STATE OF CONNECTICUT
CONNECTICUT SITING COUNCIL

IN RE:	:	
	:	
APPLICATION OF CELLCO PARTNERSHIP	:	DOCKET NO. 472
D/B/A VERIZON WIRELESS FOR A	:	
CERTIFICATE OF ENVIRONMENTAL	:	
COMPATIBILITY AND PUBLIC NEED FOR	:	
THE CONSTRUCTION, MAINTENANCE	:	
AND OPERATION OF A WIRELESS	:	
TELECOMMUNICATIONS FACILITY AT	:	
541 BROADBRIDGE ROAD IN	:	
BRIDGEPORT, CONNECTICUT	:	MAY 23, 2017

**RESPONSES OF CELLCO PARTNERSHIP D/B/A VERIZON WIRELESS
TO CONNECTICUT SITING COUNCIL PRE-HEARING QUESTIONS, SET ONE**

**Proposed Verizon Wireless 700 MHz Coverage
Centerline Heights of 82' and 72' AGL
Bridgeport, Connecticut and Surrounding Area
(*Map Scale is 1:20,000)**
Coverage is depicted at a signal threshold of 120 dB Operational Path Loss

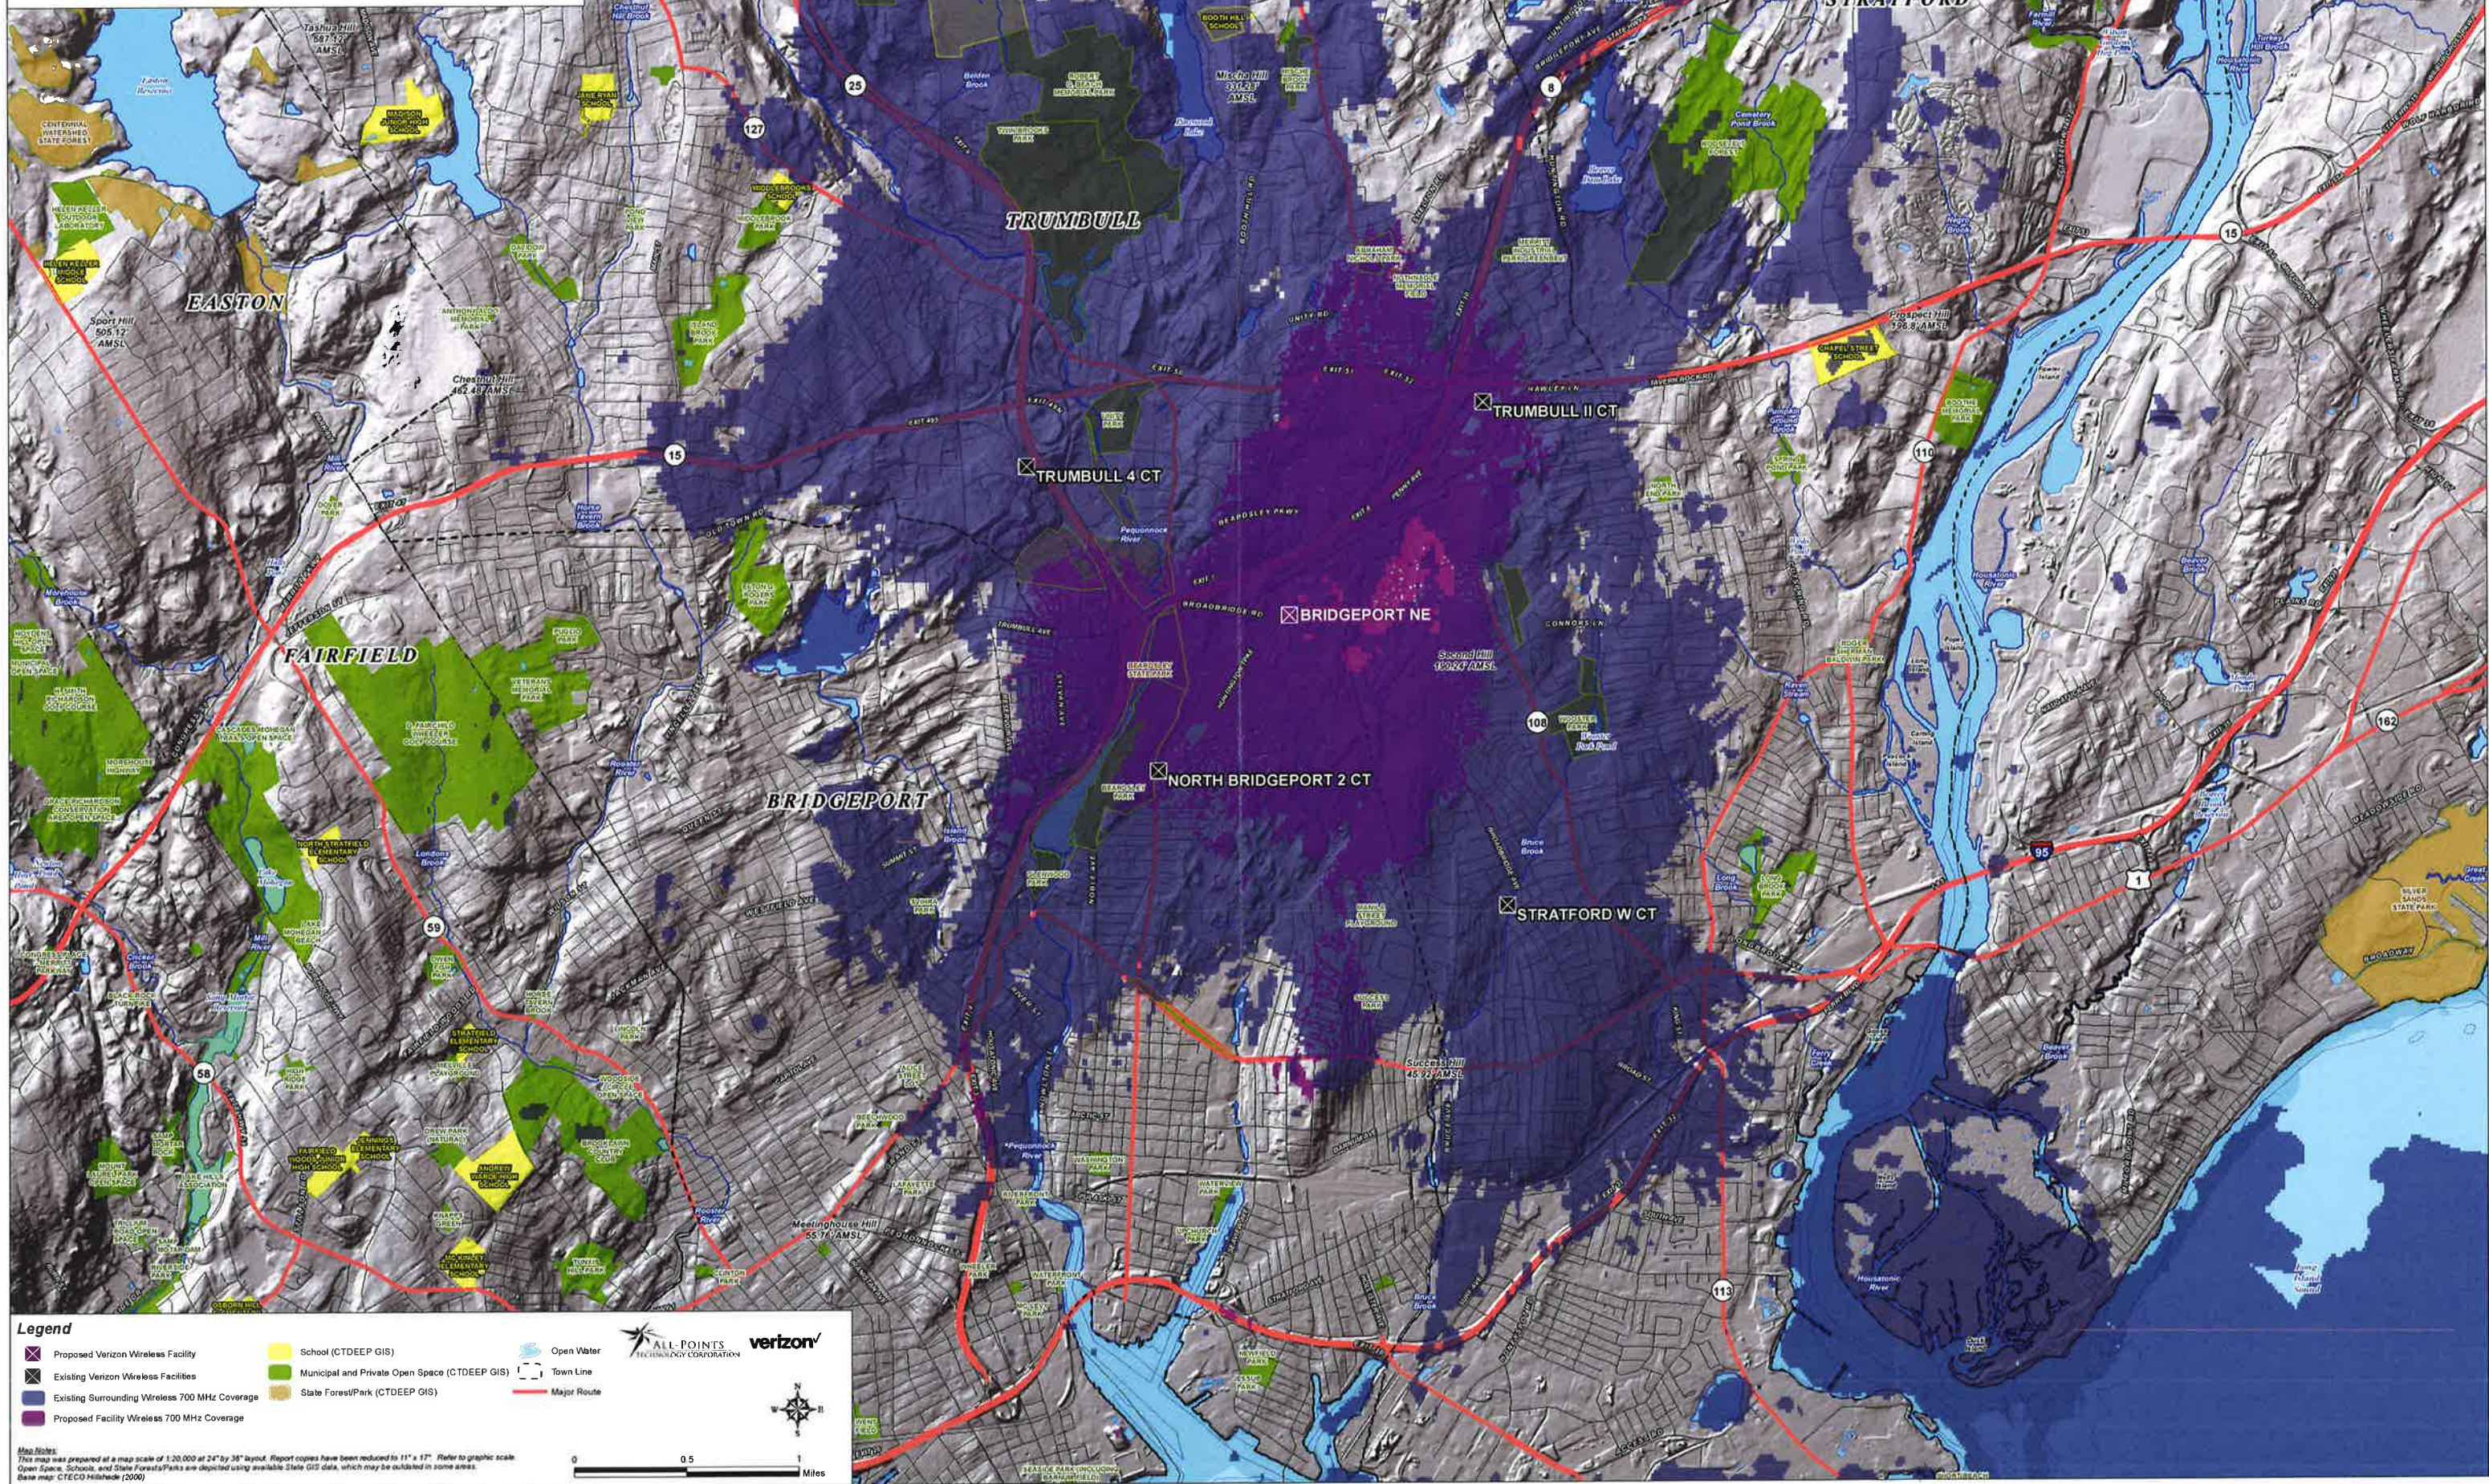
Similar to the propagation maps provided in the Application, submit propagation maps for all four frequency bands (i.e. 700 MHz, 850 MHz, 1900 MHz, and 2100 MHz) assuming that the tower is ten feet shorter than proposed (i.e. antennas are installed at centerline heights of 82 feet and 72 feet agl).

The propagation maps requested are included in Attachment 1.
